TECHNICAL INSTRUCTION

TI 016
Issue 1
April 2005
Page 1 of 2

NETWORK RAIL - SIGNAL ENGINEERING

Typical Circuit – LED Shunt Signal Retrofit

Fig. I

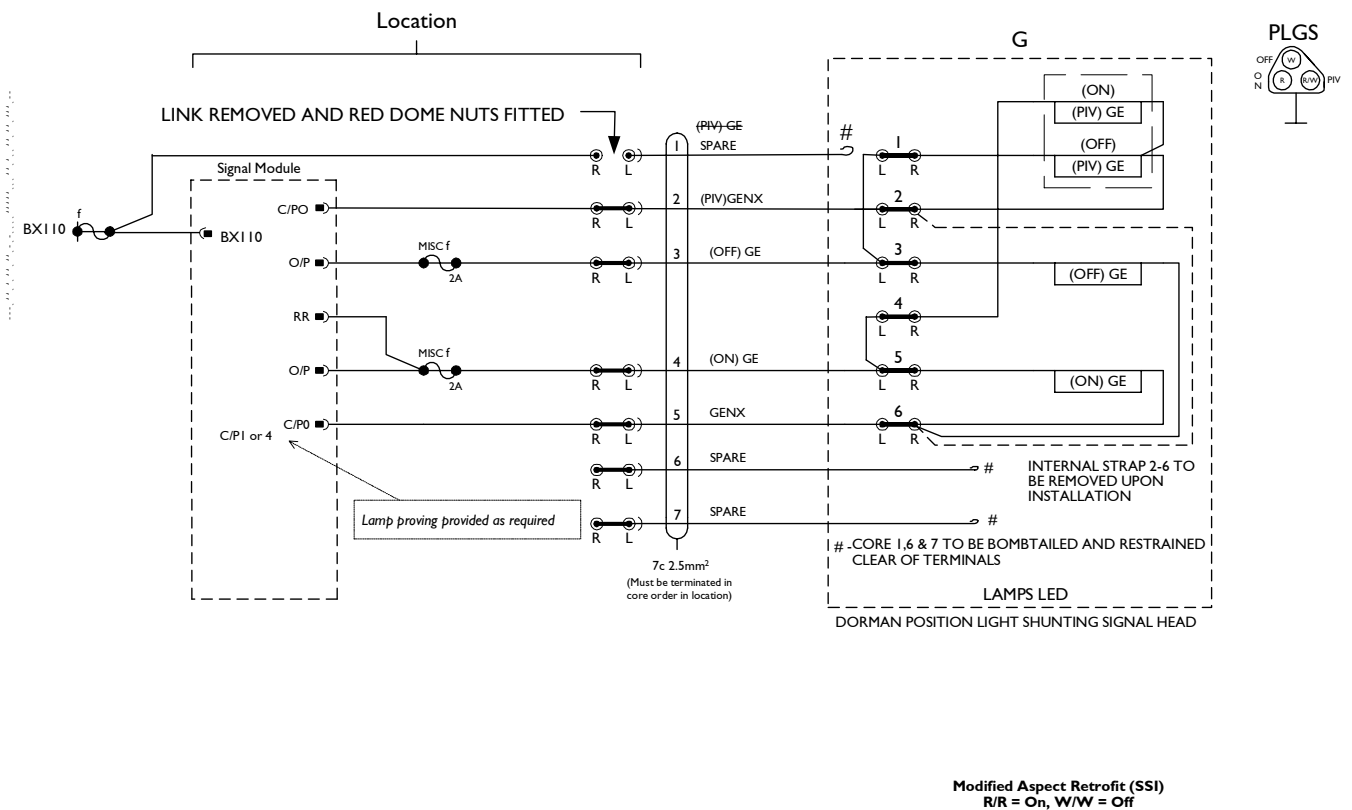
LED Shunt signal Retrofit (SSI) Figure - I

This circuit to be used for replacement of 110V lamp head with Dorman LED units using RED/WHITE pivot lights. No data change is required.

Fig. 2

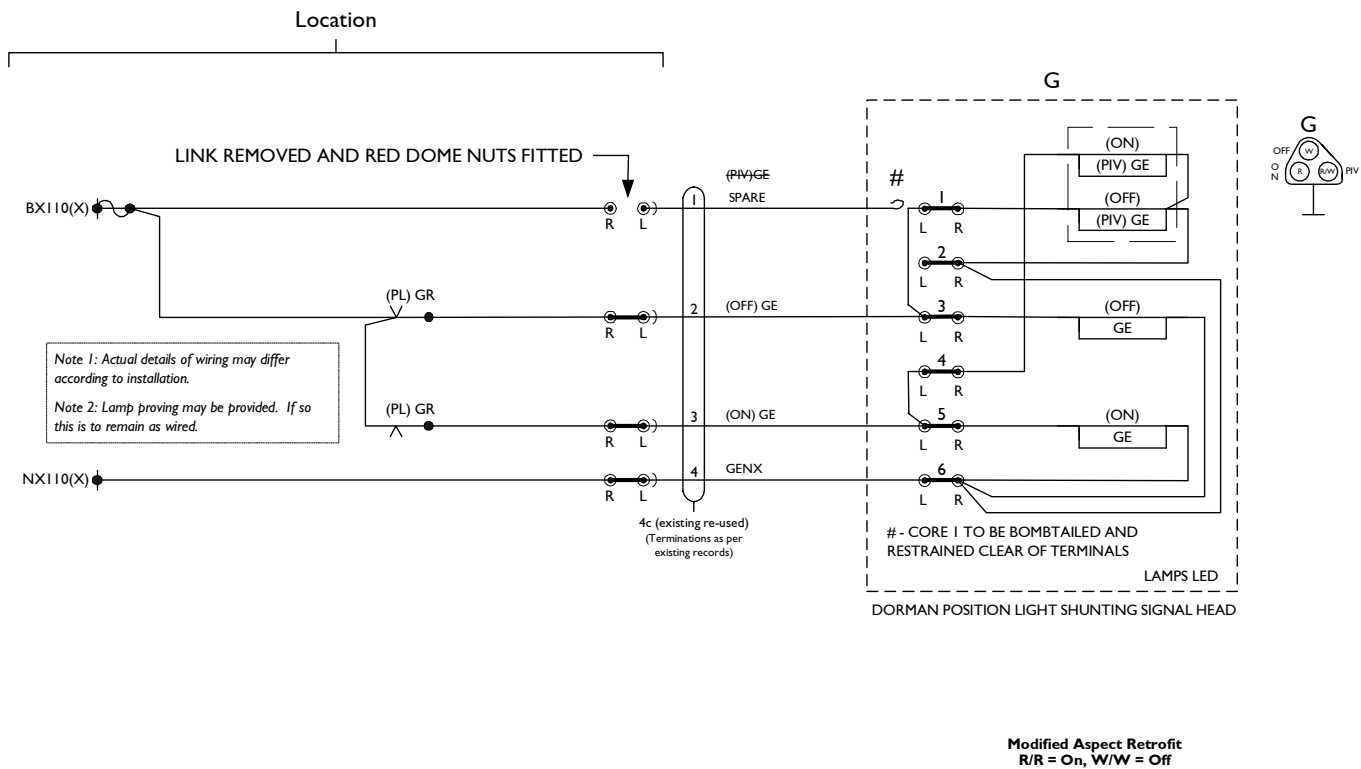
LED Shunt signal Retrofit (RRI) (Figure – 2)

This circuit to be used for replacement of 110V lamp head with Dorman LED units using RED/WHITE pivot light.
